## **Nelson Street plans**

### Introduction

This note records comments made by Bristol Civic Society on draft plans for Nelson Street. The plans are for changes funded by the Cycling Ambition Fund programme. These comments follow an on-site visit on 11th September 2017 by 5 of us.

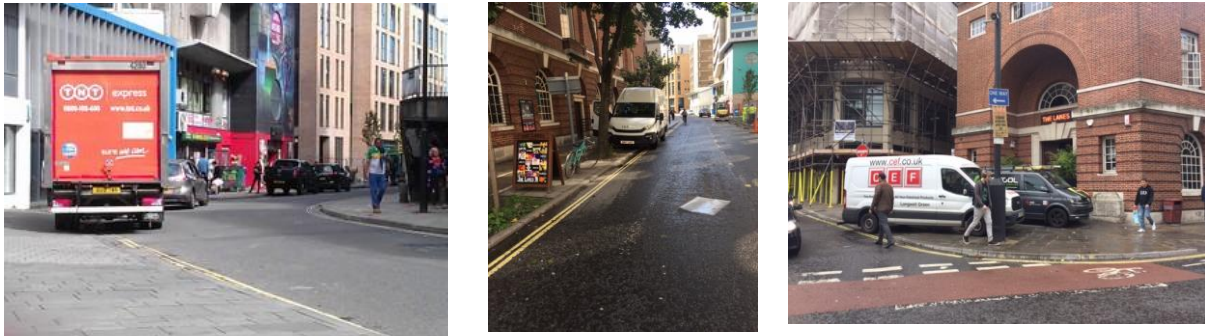
Pavement parking and illegal parking on double yellow lines is rife, thus increasing the feeling of motor traffic domination. See photos below.
